Pickwick Association

The Planning Inspectorate
Room 3/C Eagle Wing, Temple Quay House
2 The Square
Bristol
BS1 6PN
For the attention of Mr Sean Ernsting
Your reference APP/Y3940/W/18/3204107

Town and Country Planning Act 1990
Appeal by Gladman Developments Ltd
Site Address: Land North of Bath Road, Corsham, Wiltshire, SN13 0QL

The Pickwick Association strenuously opposes the appeal by Gladman Developments against the Wiltshire Council's refusal to permit the variation of Condition 22 of Planning Inspectorate Decision of 27 May 2015, reference APP/Y3940/A/14/2222641

Figure 1: Extract from Wardell Armstrong drawing No. LE11761-004 showing historic mining activity beneath the development site and approximate location of current mining activity

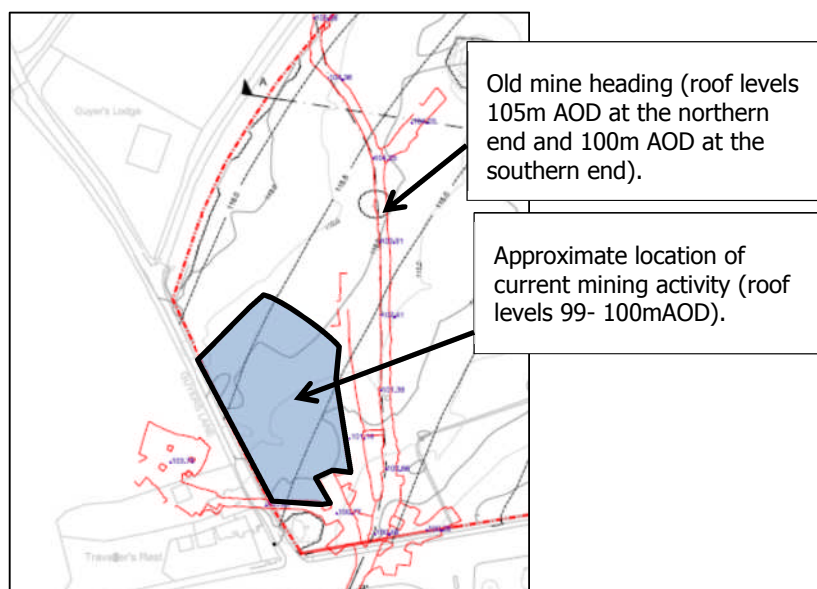
The current operator of the Hartham Park Quarry, Lovell Stone Group Limited (LSG), is presently mining beneath the south-western portion of the development site, between the western site boundary and the old heading⁴ known to run approximately north to south beneath the western part of the site (see Figure 1). The new mine workings are advancing generally to the north at present but LSG's lease allows it to advance in an easterly direction to a line roughly halfway across the site (see Drawing No. PICKWICK1705-2⁵). A plan showing how the mine workings will develop beneath the development site was attached to a letter of objection from LSG dated 9th June 2016. This shows the workings developing in three phases, worked from west to east. In the letter it is stated that, *"depending on ground conditions this [mine development] may take several years, however stone extraction will commence in this area in a matter of months."*

As far as I know, the stone beneath the eastern half of the site, whilst covered by the same planning permission, is in different ownership from that leased to LSG and I am not aware of any short or medium term plans to exploit this part of the reserve.

Date 07.06.2017	Drawn RA/EMB	Checked AEC	Scale 1:10,000 at A3
Drawing Ref PICKWICK1705	Drawing No 1	Version C

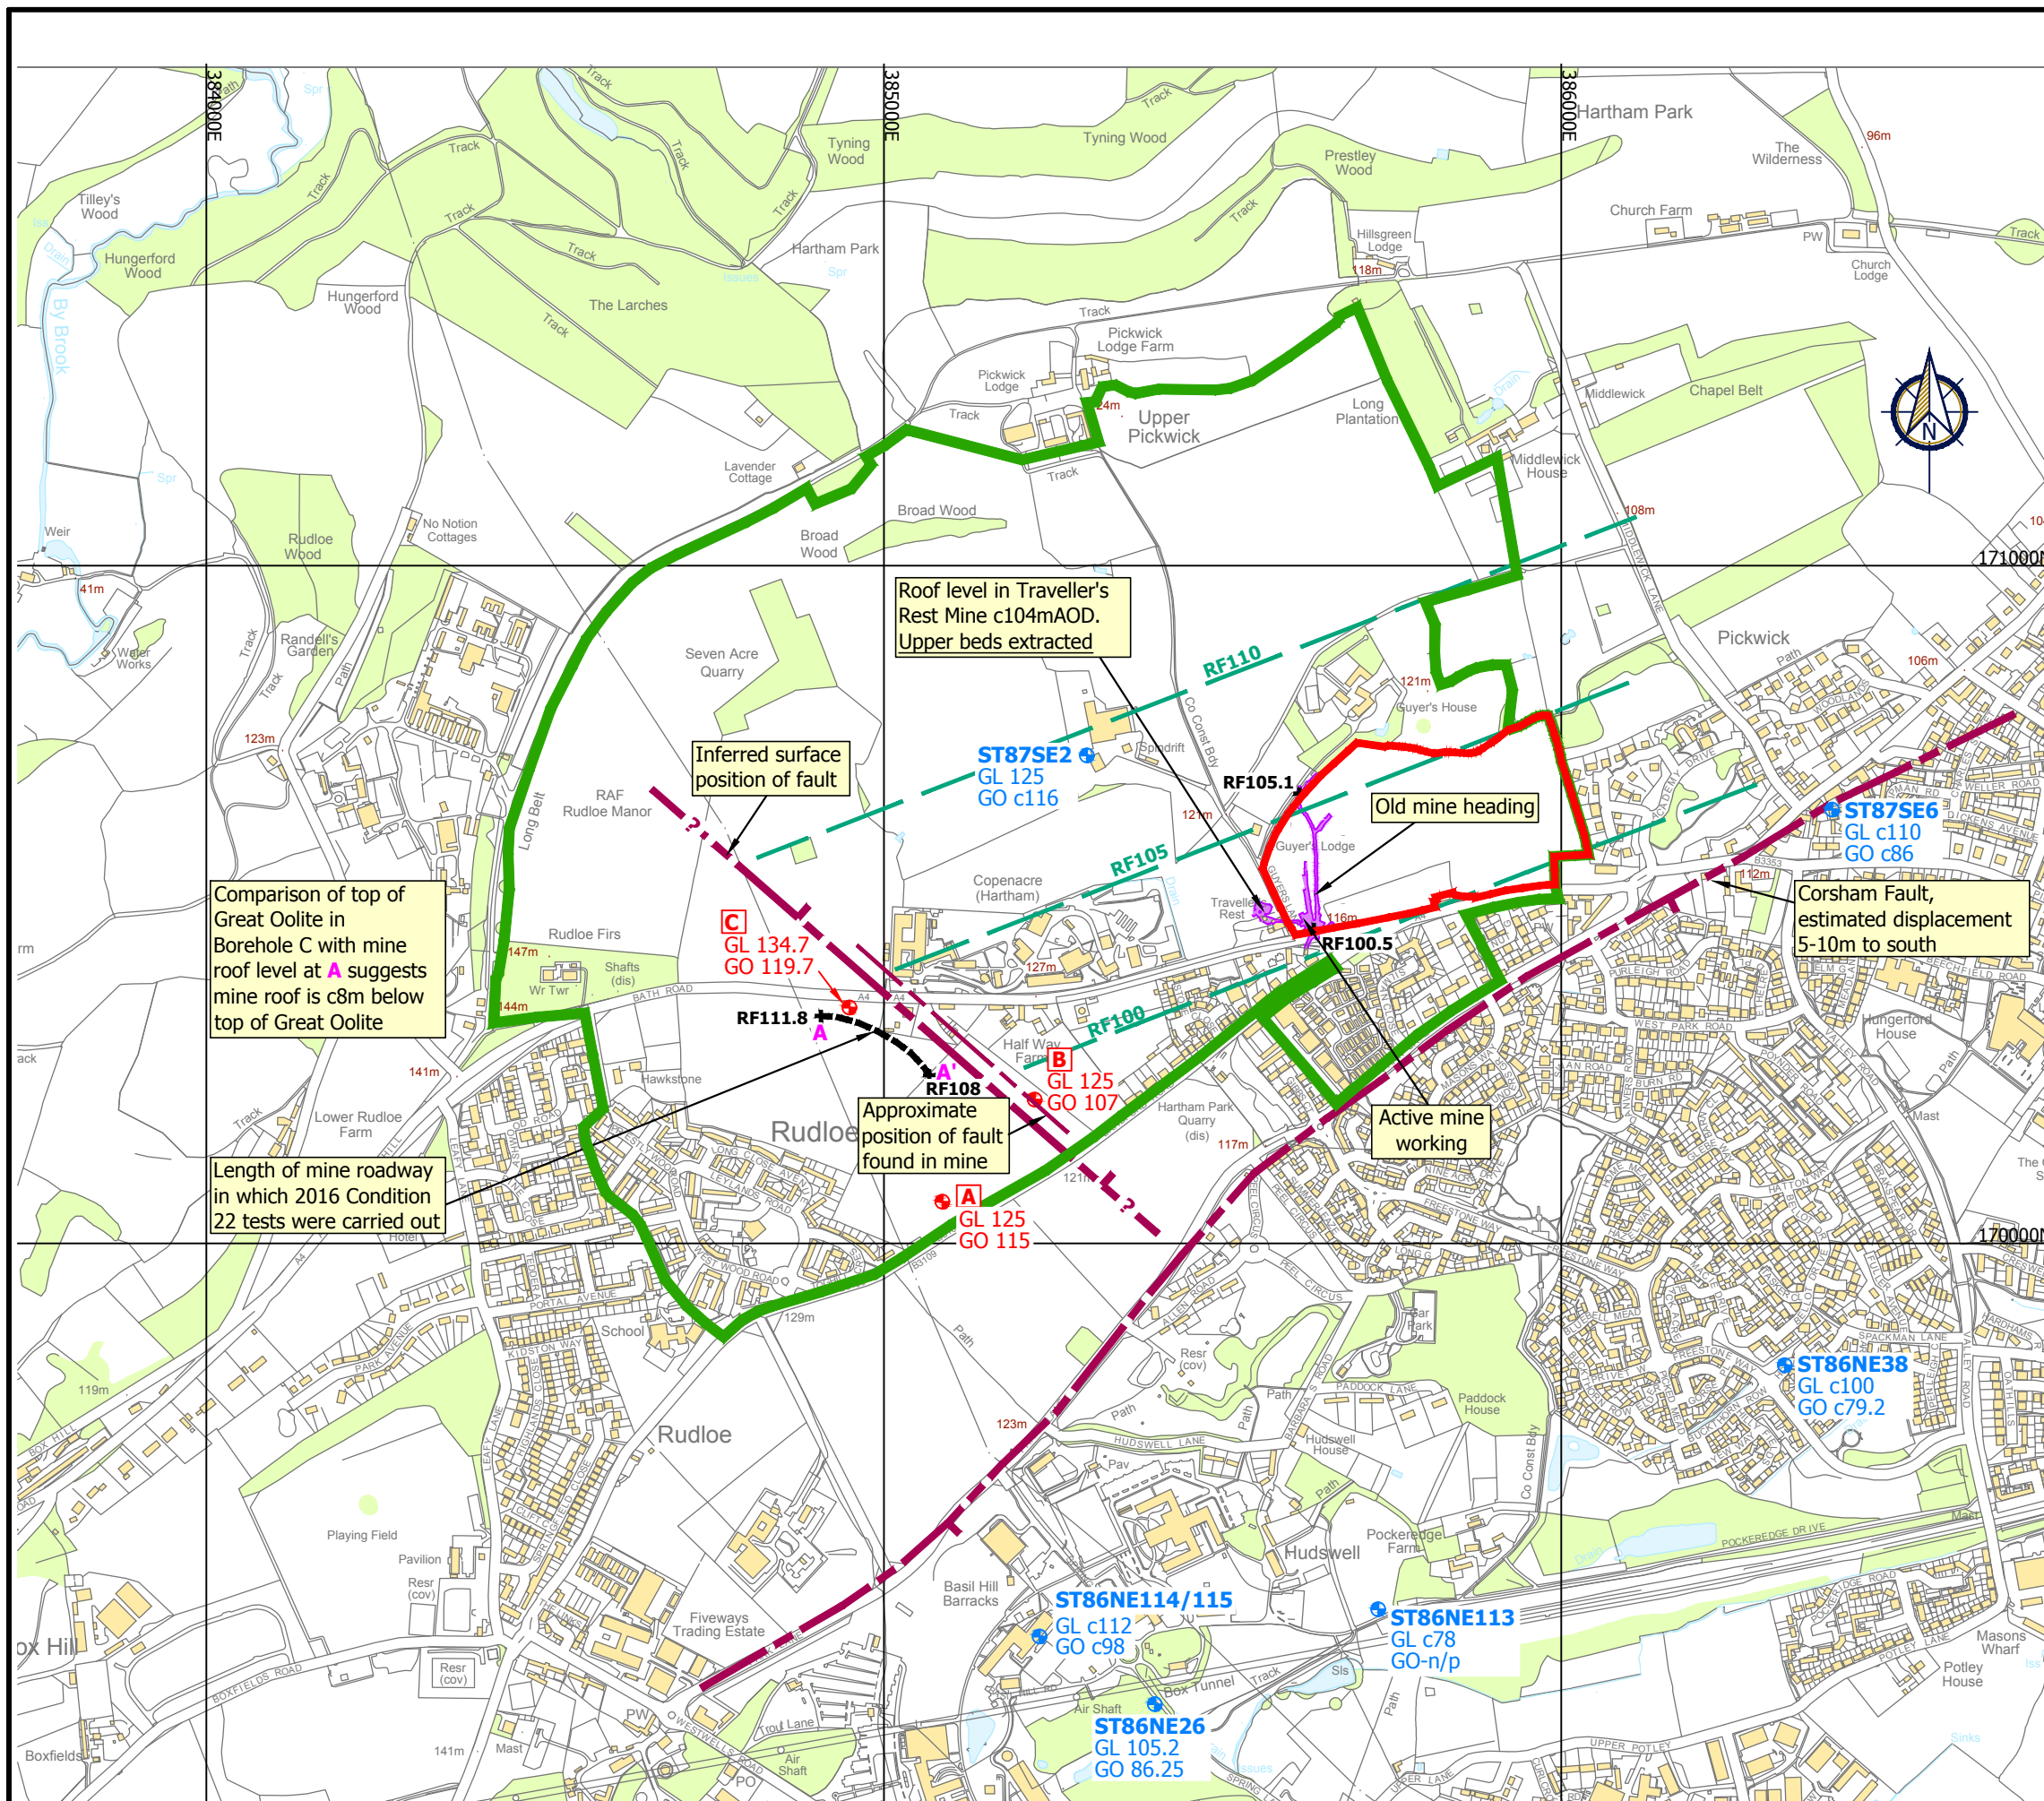
The development site is within the boundary of an extant planning permission for the underground mining of Bath Stone. This permission³ is valid until 2042 and extends across the whole development site (see Drawing No. PICKWICK1705-1).

Absent any relevant intrusive geological investigations at the development site, it is necessary to use available published and publicly available geological information as well as survey and other available information about the mine to determine the depth at which future mining is likely to take place beneath the development site. On this basis, I have developed the geological and mining model depicted on Drawing No. PICKWICK1705-1.

Furthermore, by reference to Drawing No. PICKWICK1705-1 and the contours on the published 1:25,000 Ordnance Survey map sheet¹⁸ I estimate that the depth to the mine roof in old workings that lie beneath buildings in the triangular area between Bath Road and Bradford Road and in the light industrial development north of Bath Road and west of the development site is between 22 and 25m.

Date	07.06.2017	Drawn	RA/EMB	Checked	AEC	Scale	1:2000 at A3
Drawing Ref	PICKWICK1705	Drawing No	2	Version	C

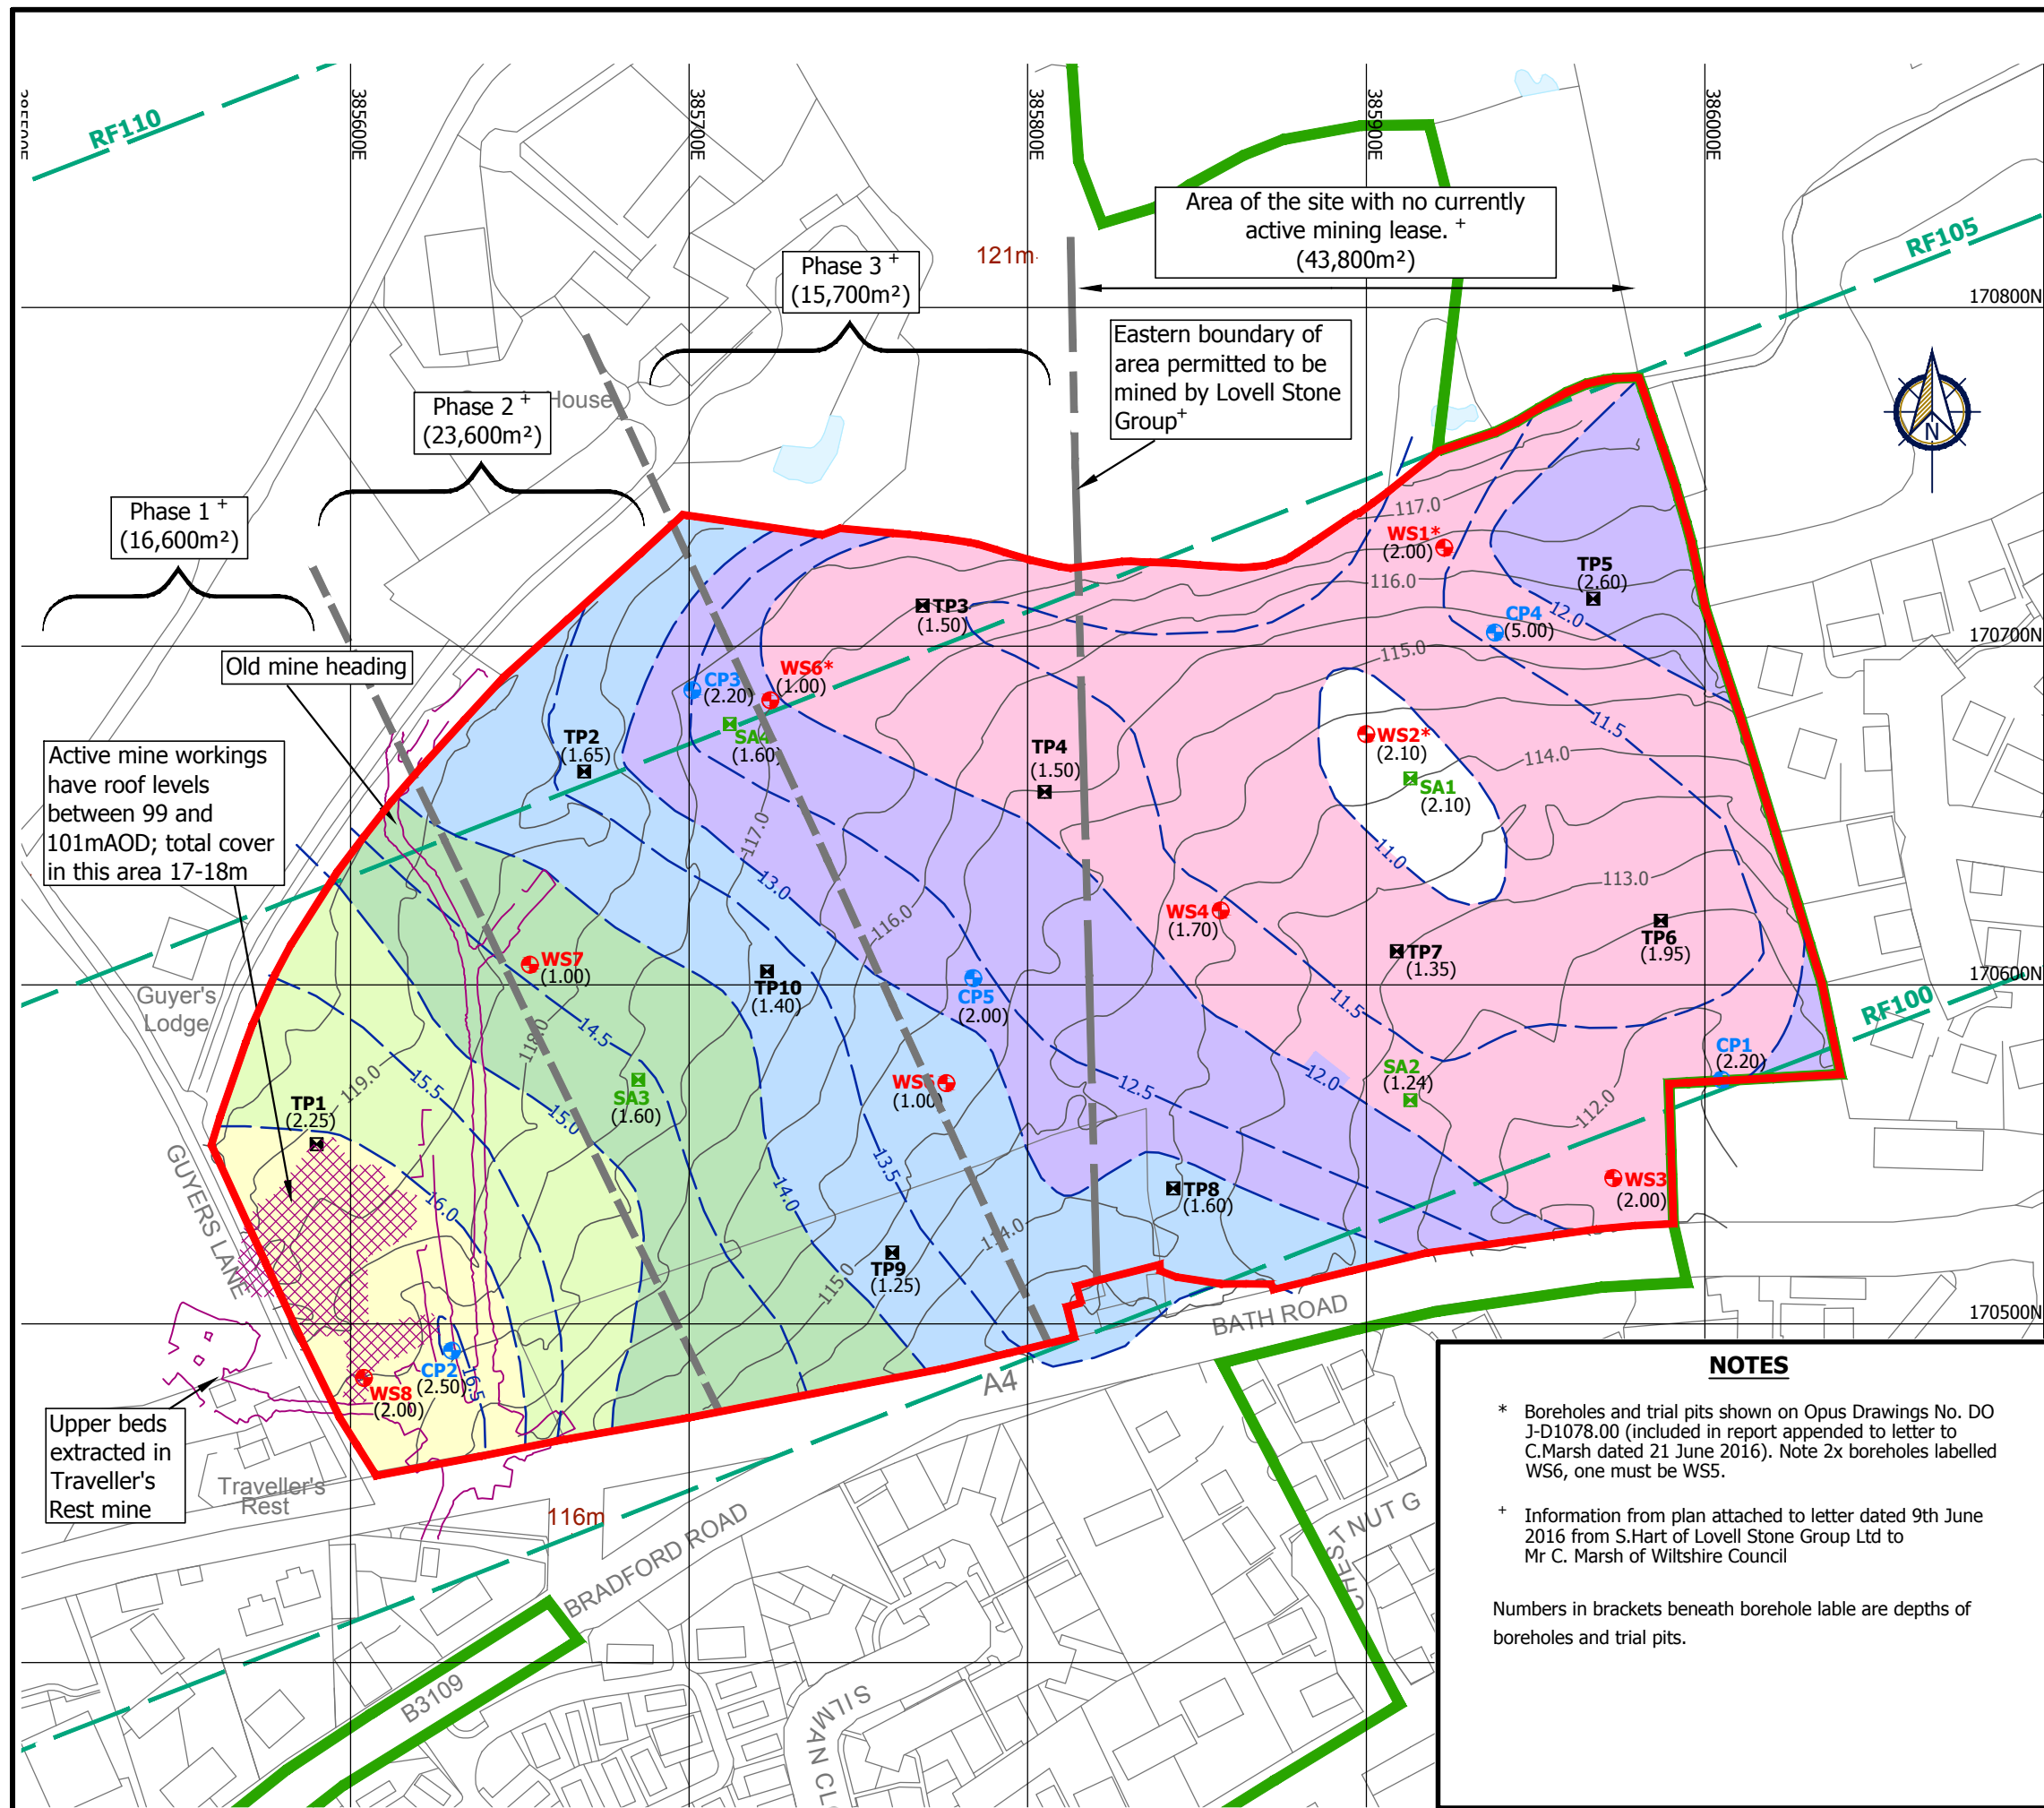
Drawing No. PICKWICK1705-2 depicts isopachytes¹⁶ for the thickness of total cover above mine workings with their assumed roof levels 8m below the inferred top of the Great Oolite, and Table 1 below summarises the results of estimates of bedrock and total cover derived from my geological/mining model in combination with surface and rockhead contours provided by the promoter's consultants. It is predicted that the total depth from the ground surface to the mine roof within the development site will be between a minimum of 11m (in the eastern half of the site) and a maximum of 17m (near the old air shaft).

Using the rockhead contours shown on WA Drawing No. LE11761-004¹⁷, I calculate that the maximum intact rock thickness ("rock cover") above the mine roof would be 14m in the western part of the site and **not** "*approximately 17.5m*" or "*of the order of 20m*" as asserted in the Wardell Armstrong method statement. Beneath the eastern part of the site, my analysis shows that the minimum thickness of intact rock cover is 8.25m. If the mine operator were also to extract the upper beds (as he is perfectly entitled to do), the rock cover beneath the development site would further reduce to a maximum of between 11m and 12m on the western side of the site and to between 5.25m and 6.25m in the east.

As is shown on Drawing No. PICKWICK1705-2 and described in Section 3.1.5 above, thicknesses of rock cover in future mine workings beneath the development site are expected to be below 17m, whereas old workings south of the Bath Road appear to have rock cover thicknesses that are more consistent with the 6x multiplier.

As is shown on Drawing No. PICKWICK1705-2, the thinnest cover above future mine workings within LSG's lease area will be in the northern third of Phase 3, where total cover is expected to be between 11.5 and 12m. I have estimated (see Section 3.1.4 above) that it will take between 7 and 14 years to work through Phases 1 and 2.
